RE: Elekta Inc. 10 CFR 21 Notification for the Applicator Modeling measured source path error

**Subject:** Incorrect source step size may occur in Oncentra Brachy plans for Ring or Venezia applicator models with microSelectron.

**Product:** Oncentra® Brachy.

**Scope:** Oncentra Brachy versions 4.5, 4.5.1, 4.5.2.

Figure 2. Example of the 3D reconstruction area with the differences in the step size.

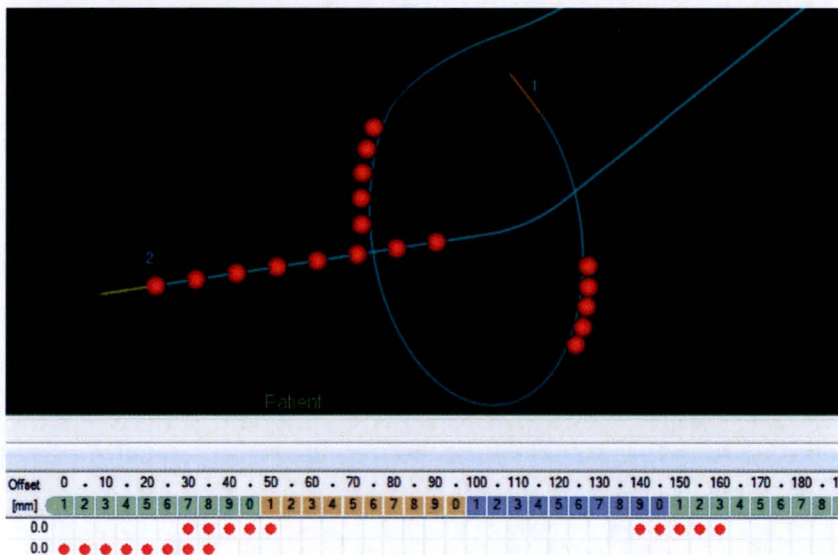
The 3D view of the applicator will show a step size of 2.5 mm for the ring and 5.0 mm for the tandem, see Figure 2. When activating dwell positions in the Case Explorer, it seems a 5.0 mm step size is used, while the 3D view shows a 2.5 mm step size for the ring.

The dose calculated for the plan will correspond to a 2.5 mm step size for the ring and a 5.0 mm step size for the tandem. The Oncentra Brachy Treatment Printout will show a 5.0 mm step size for both ring and tandem. When this plan is exported, a step size of 5.0 mm will be sent to the microSelectron afterloader. The afterloader Pre Treatment Report will show a 5.0 mm step size as will be delivered by the afterloader.

Until an upgraded version of Oncentra Brachy is available, it is strongly recommended to only use a default source step size of 2.5 mm for microSelectron afterloaders in RDStore.

If a larger default source step size is required in RDStore, a workaround is to reselect the same afterloader in the Prescription dialog in the Oncentra Brachy planning module. The source step size is then forced to the correct value of 2.5 mm.
